22-330 Lot 177 Woodside Ridge
Lee's Summit, Missouri

COMPLIANCE LETTER

Image 1: Breakfast/Kitchen & Gathering room beam location

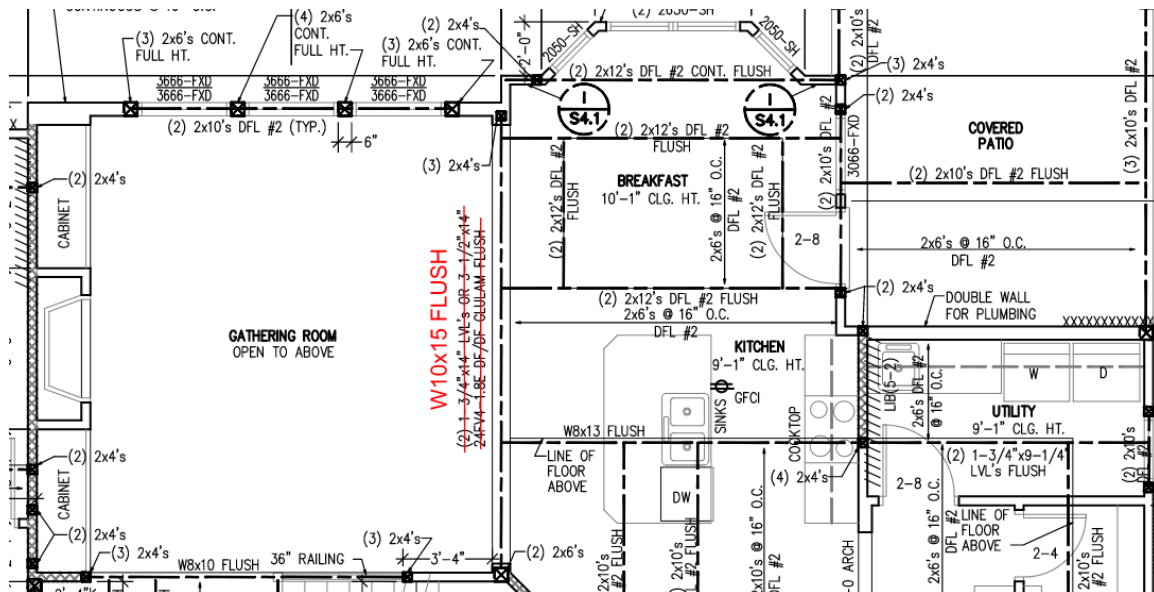
- The flush beam between the kitchen/breakfast and gathering rooms to change from the 16" LVL beams to a steel beam.
 - After review, the acceptable steel beam size shall be a W10x15. See plan location below.**
